CAMECO RESOURCES
*Smith Ranch-Highland
Operation*
Mail:
P.O. Box 1210
Glenrock, WY
82637 USA

RE: Minor Revision to Source Material License SUA-1548, Docket No. 40-8964

Attachments: Proposed Revision to Figure 3-13, Proposed Revision to Section 6.1

**Figure 3-13
Smith Ranch-Highland Uranium Project - Estimated Time Table of Mining Related Activities**

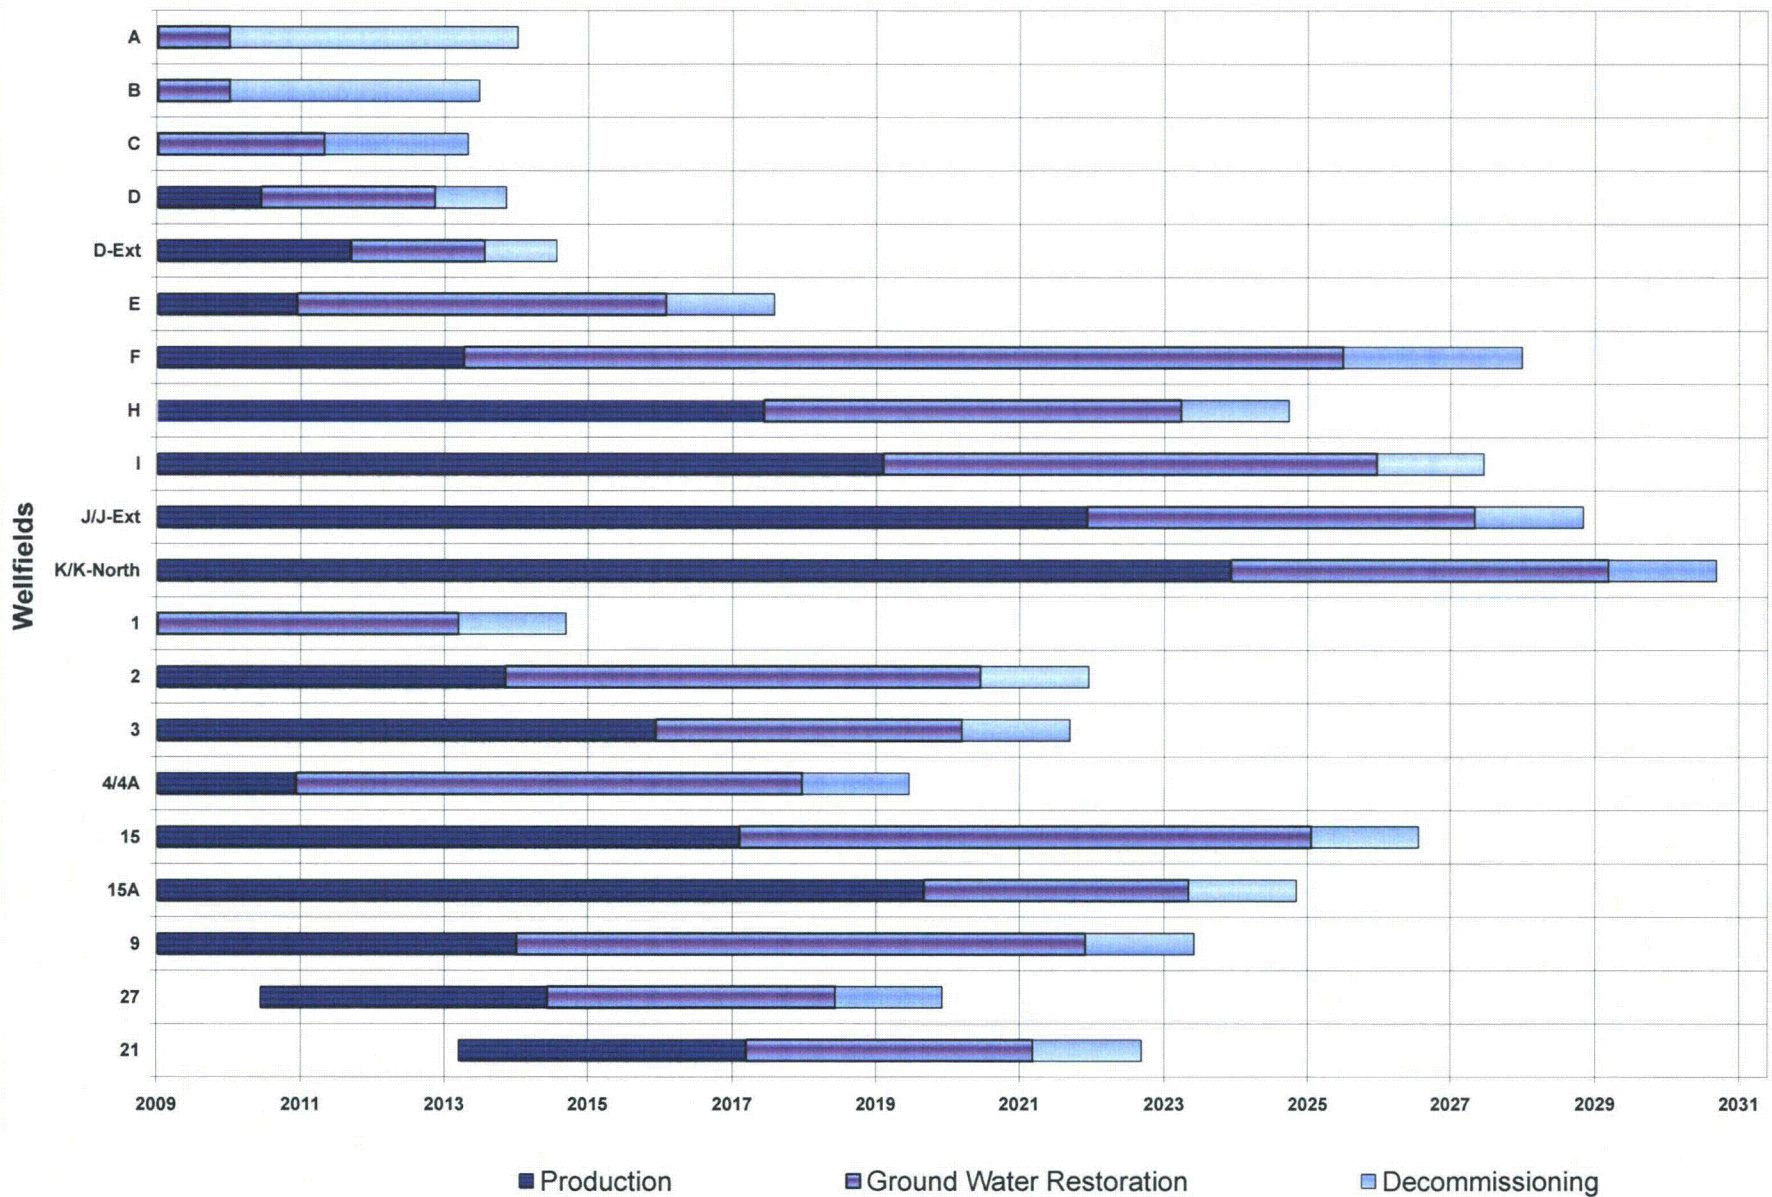
The update to Figure 3-13 is a routine revision of the production, restoration, and reclamation timetable to reflect current mining and restoration plans. Section 6.1 updates include removal of references to Ground Water Transfer and Electrodialysis Removal because they have not been used at this site and are not being considered for use. Satellite No. 2 Restoration Plant is currently under construction and a description of the processes in the plant has been added to Section 6.1. These processes mirror processes used in previously approved operations (e.g., sand filters, ion exchange columns, reverse osmosis) and also include a basic clarifying circuit.
